**MITSUBISHI HEAVY INDUSTRIES, LTD.**  
16-5, KONAN 2-CHOME, MINATO-KU  
TOKYO, JAPAN

**Subject:** MHI's Responses to US-APWR DCD RAI No. 342-2000

**Reference:** 1) "Request for Additional Information No. 342-2000 Revision 0, SRP Section: 03.08.04 – Other Seismic Category I Structures, Application Section: 3.8.4," dated 4/21/2009.

**US-APWR Design Certification  
Mitsubishi Heavy Industries  
Docket No. 52-021**

Figure 1 Dynamic hydraulic pressure distribution

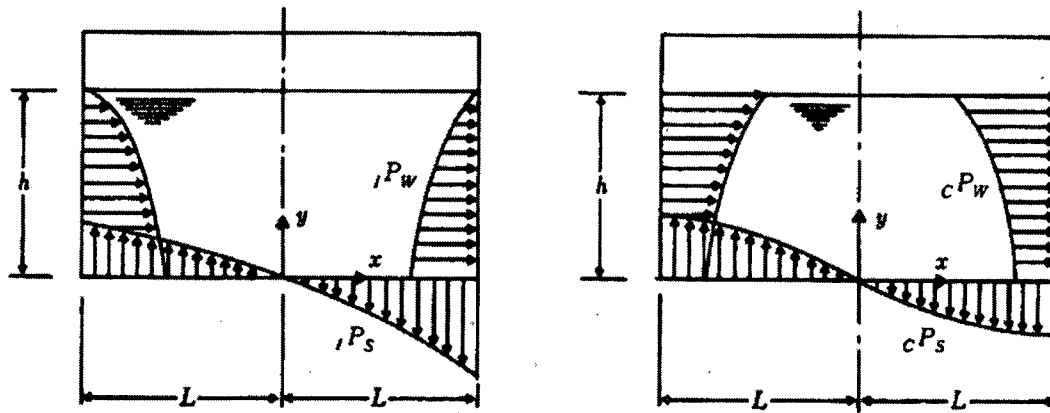
Were the hydrodynamic loads associated with the impulsive mode included? (Note that impulse mode is that mode in which a portion of the water moves in unison with the tank, wall, and is not due to sloshing.) If yes, provide information for how they were calculated. If not, explain why they were not considered.

Hydrodynamic loads associated with the impulsive mode are included in the relevant analyses, as discussed in DCD Subsection 3.7.3.9. As clarified in the response to question 3.7.2-01 of RAI 212-1950, Revision 1, the methods used for the calculation of the hydrodynamic loads are consistent with the provisions of SRP 3.7.3, Subsection II.14 and the guidance of ASCE 4-98. Further explanation is provided as follows.

**Figure 3.8.4-4 Typical Reinforcement in West Exterior Wall – SECTION 1 (Sheet 2 of 2)**

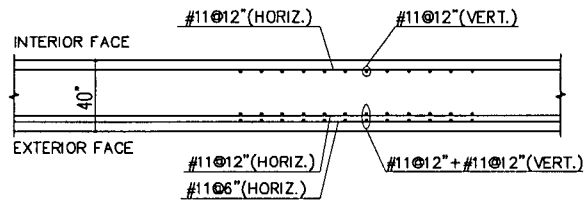
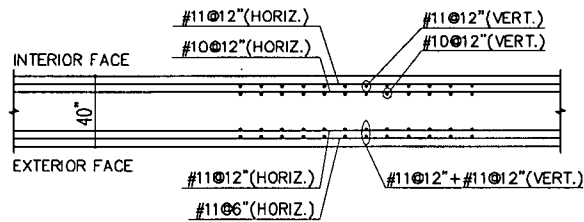
DCD Figures 3.8.4-4 to 3.8.4-7 (Pages 3.8-202 to 3.8-205) show vertical cross section views of the shear walls with re-bar layout. Provide the corresponding horizontal cross section views of these shear walls with the re-bar layout.

The DCD will be revised to add horizontal cross section views of RB and PS/B shear walls with the vertical cross section views in Figures 3.8.4-4 to 3.8.4-7.

- Insert the following as Sheet 2 of Figure 3.8.4-4:

Figure 1 E-W Section of West

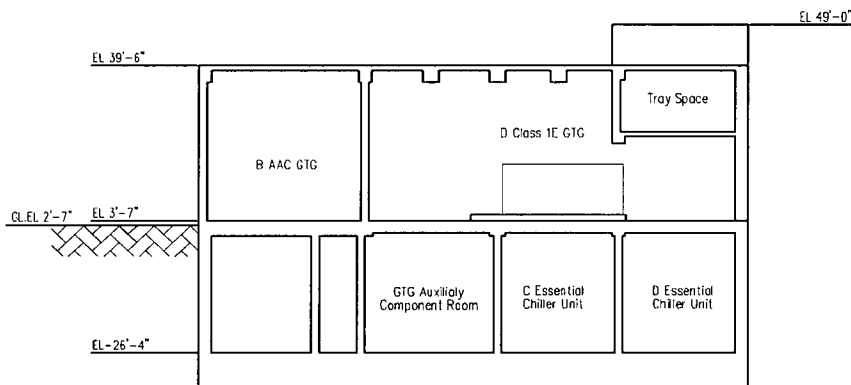
The applicant is requested to provide the following information:

In particular, the West PS/B is not worse configuration than the East PS/B. According to the simplified plane view in DCD Tier 2, Chapter 1, Figures 1.2-2 and 1.2-3, the West PS/B and the East PS/B are symmetrical structures, but the West PS/B has the tray space as shown in Figure 1 below. Accordingly, the weight of the West PS/B is larger than that of the East PS/B. The West PS/B also has unbalanced lateral soil pressures that are greater than those of the East PS/B. Therefore, the West PS/B is used as the representative building for the structure evaluation.
